PERMIT
SEWAGE DISPOSAL SYSTEM

MARYLAND STATE DEPARTMENT OF HEALTH

SUBDIVISION Sycamore Springs

LOT 4

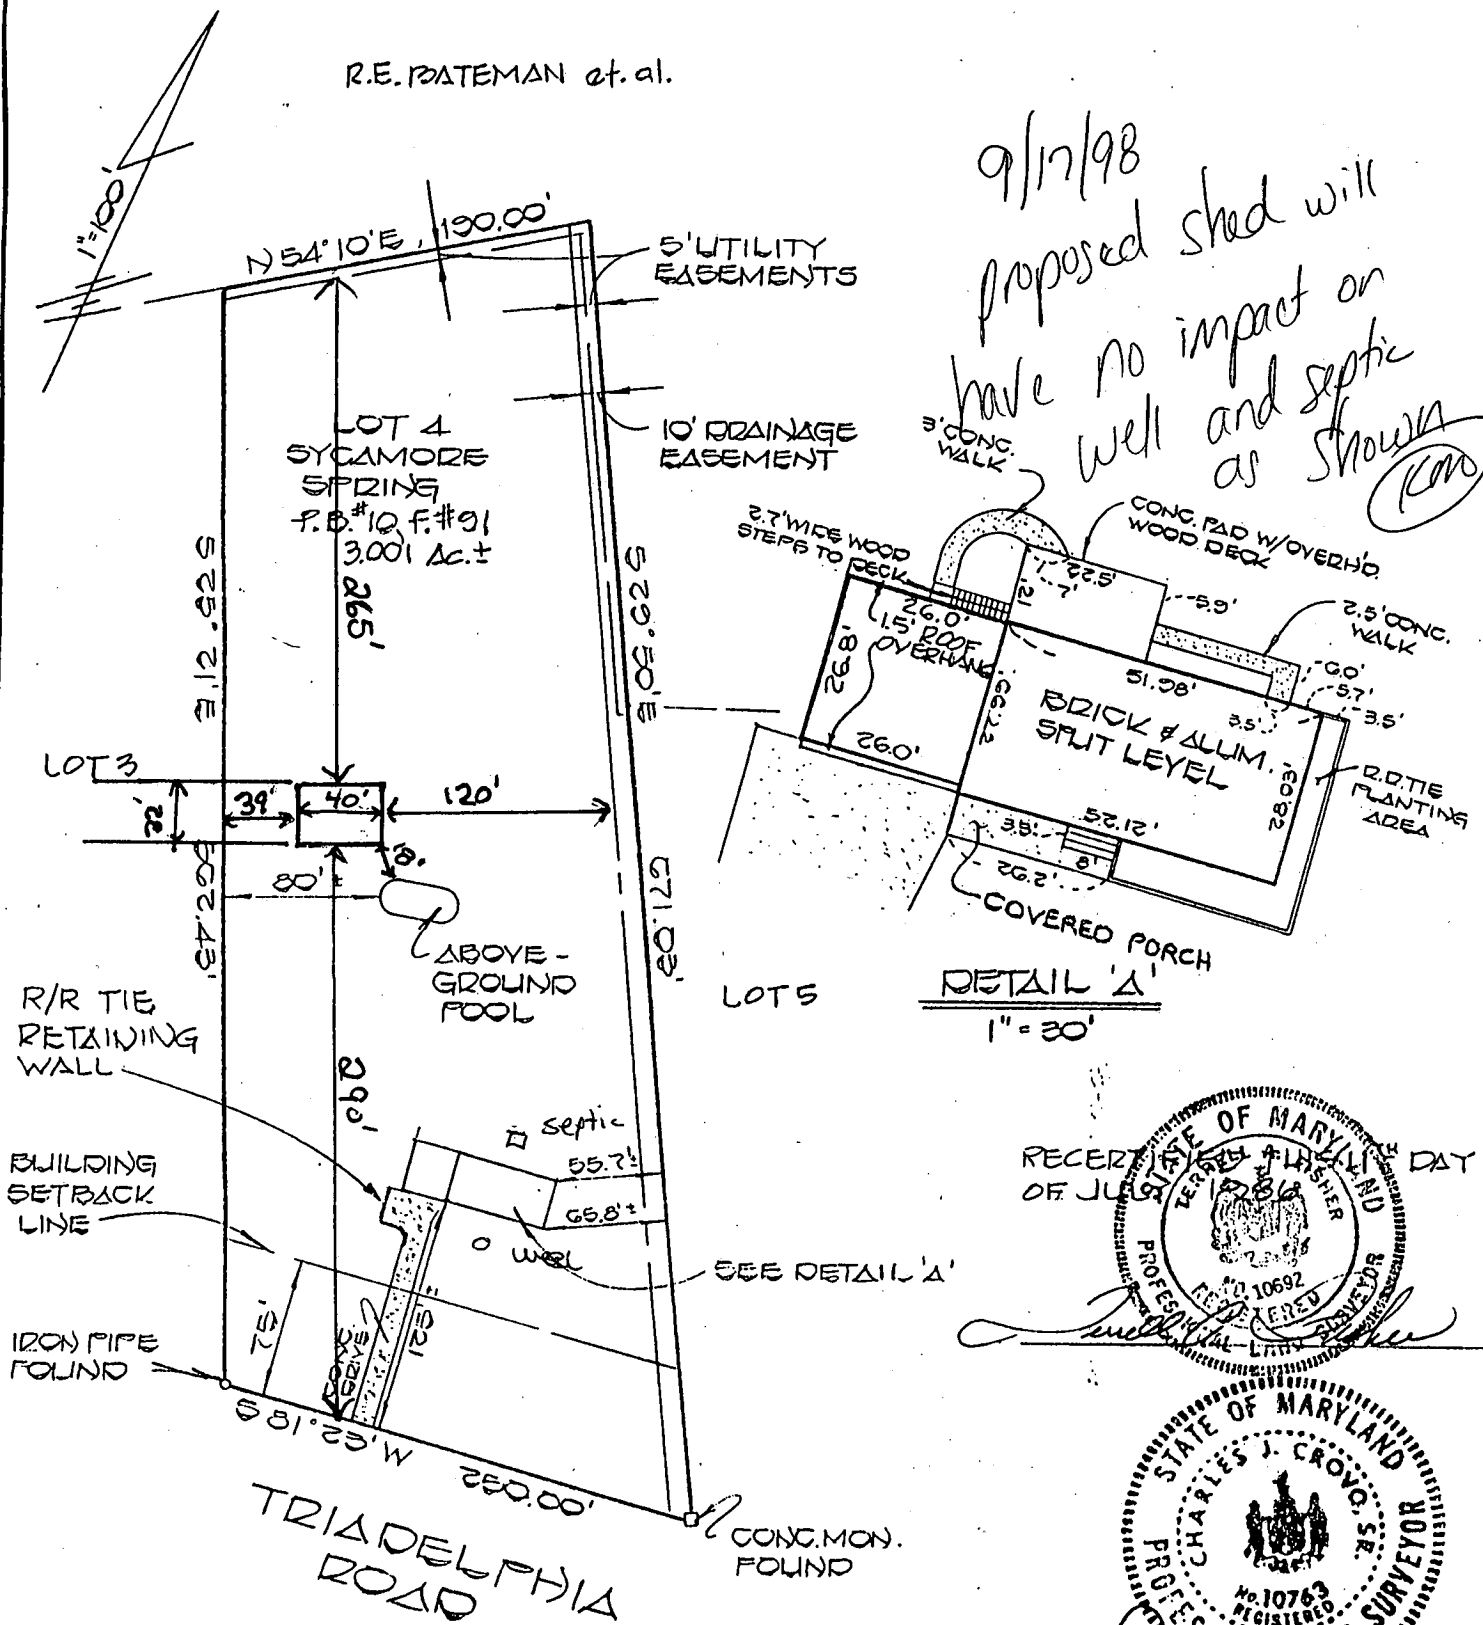
REMARKS cleanout to DW. struck in pipe; when handle
pulled, pipe pulled off of lid; reconnect properly and
free lid from pipe
